## **ADDENDUM**

**Addendum No: 3**

**Project:** UNC Charlotte East Village Infrastructure

**Date:** October 16, 2020

2. **Sheet PM-1:** Updates to bike ramp which includes 6' minimum width and reconfiguring the tactile strip as shown in yellow. Adding fillets to the sharp edges.

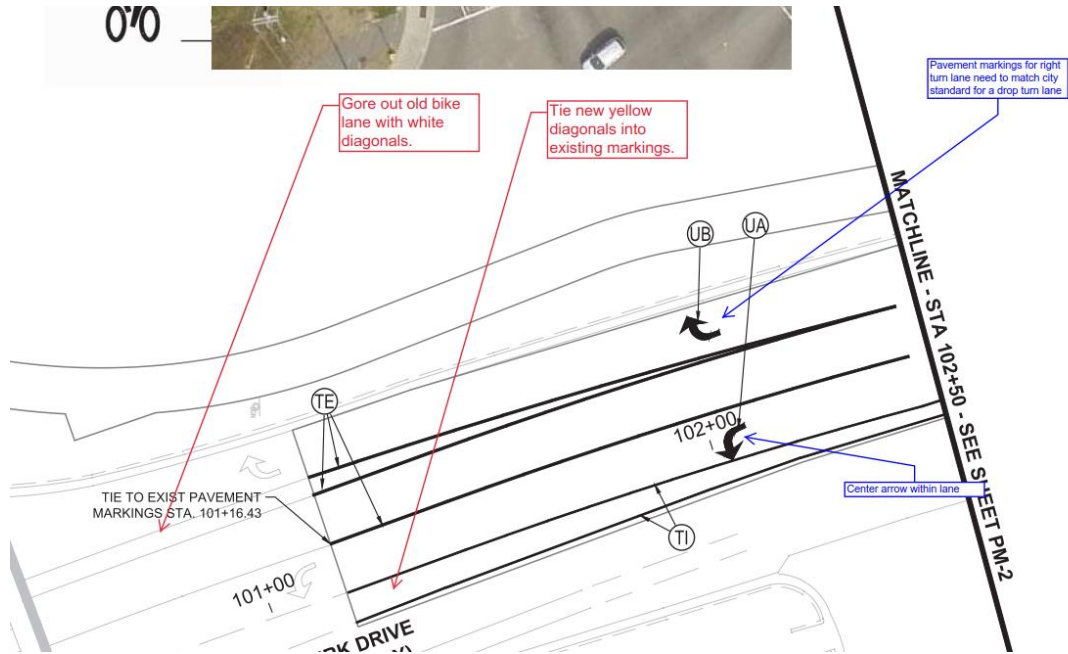
1. **Plan Sheet 6:** Updates to bike ramp which includes 6' minimum width and reconfiguring the tactile strip as shown in yellow. Adding fillets to the sharp edges.

## 4. Sheet PM-2:

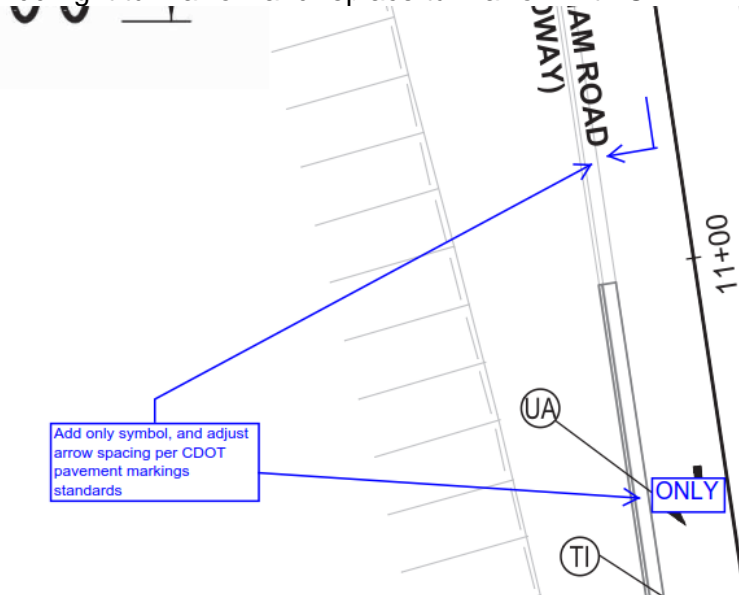
- i) Add right turn arrow and replace turn arrow with ONLY marking.

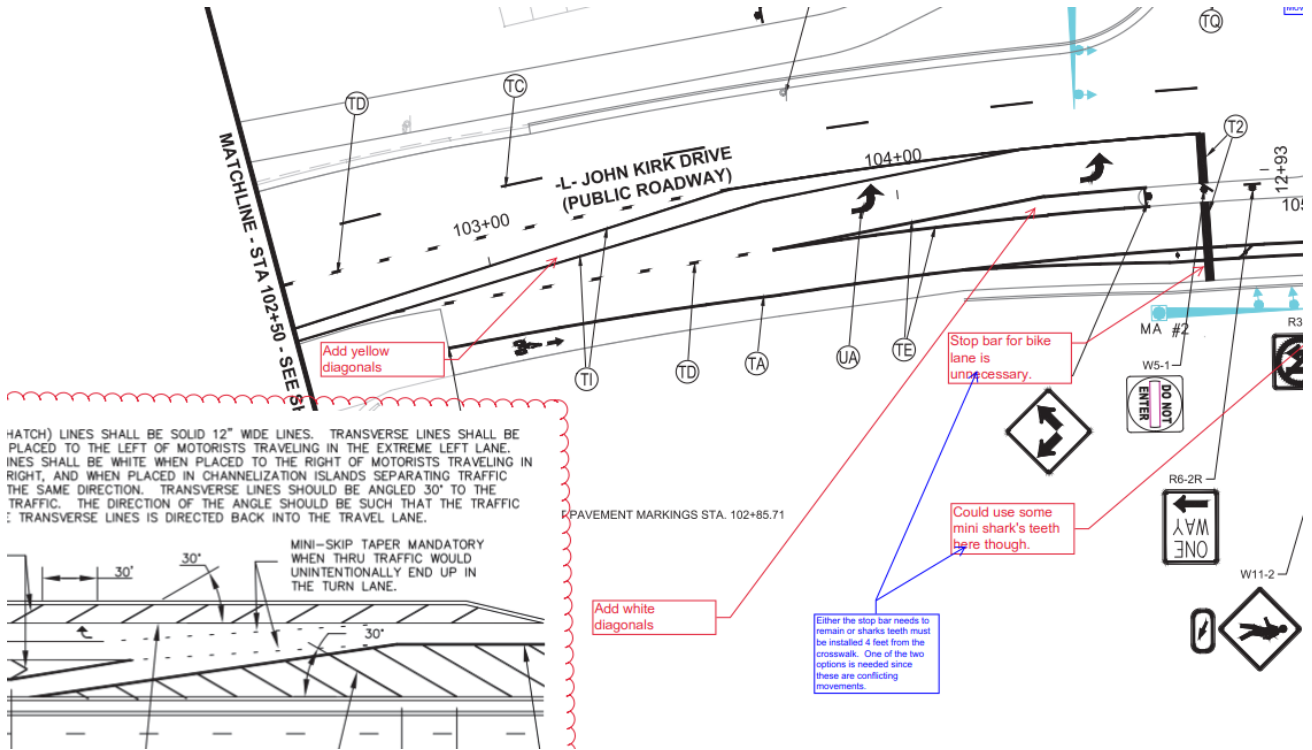
- ii) Add yellow diagonals from station 101+25 to 104+00 spaced every 30'
- iii) Add white diagonals station 104+00 to 104+60
- iv) Change bike lane stop bar to sharks teeth

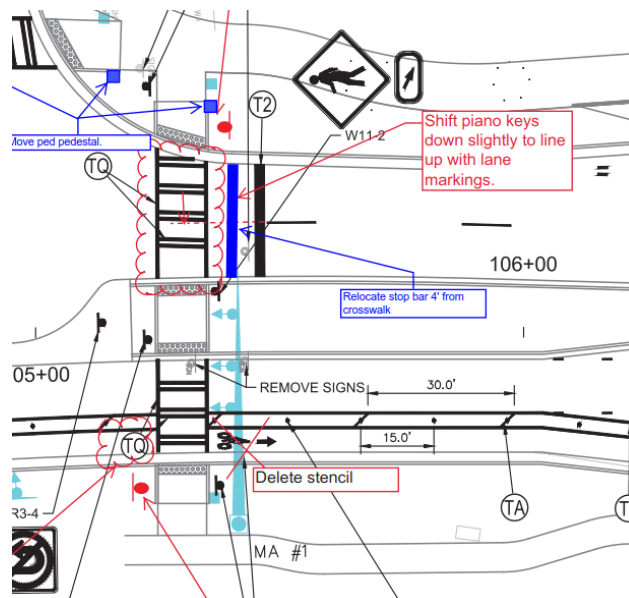
- v) Shift piano keys to line up with lane markings
- vi) Relocate stop bar to be 4' from crosswalk
- vii) Remove bike lane stencil

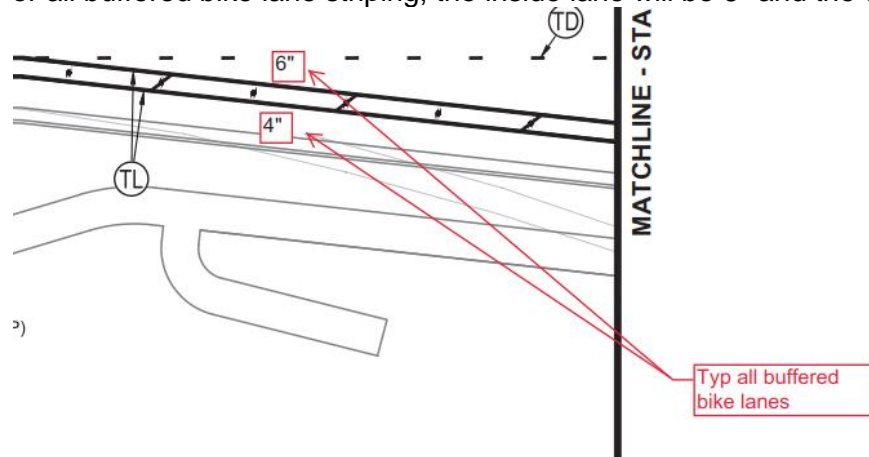
viii) For all buffered bike lane striping, the inside lane will be 6" and the outside lane will be 4"

## 5. Sheet PM-3:

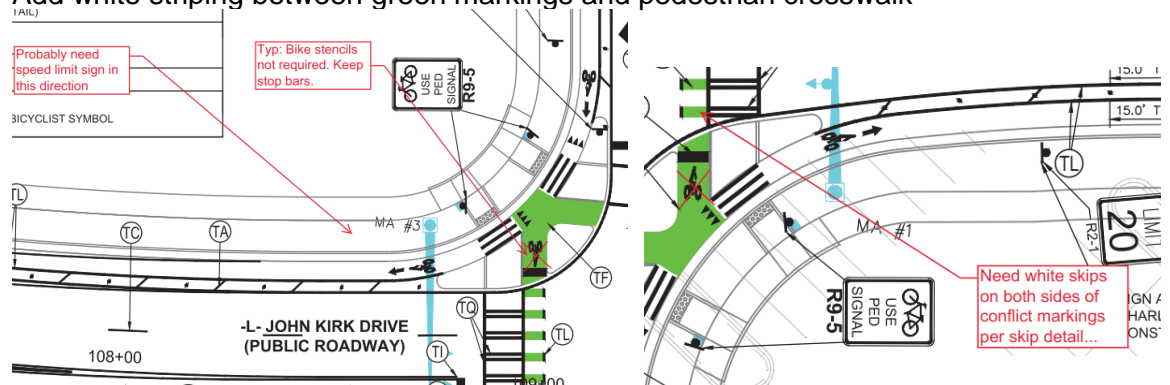
i) TF in the plans will be Methyl Methacrylate instead of thermoplastic

ii) Add speed limit sign at station 108+50 (left)

iii) Remove bike symbols within green striping

iv) Add white striping between green markings and pedestrian crosswalk

v) All speed limit signs on John Kirk Drive to be 30 mph

## 6. Sheet PM-4:

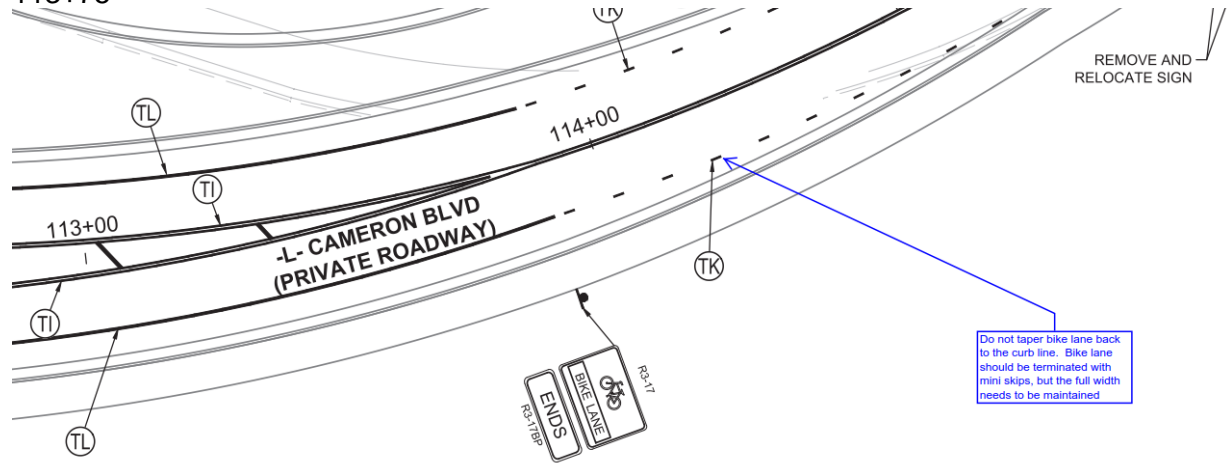
- i) Update striping to end bike lane with full width of 5. Move miniskips to start at 113+00 to 113+75
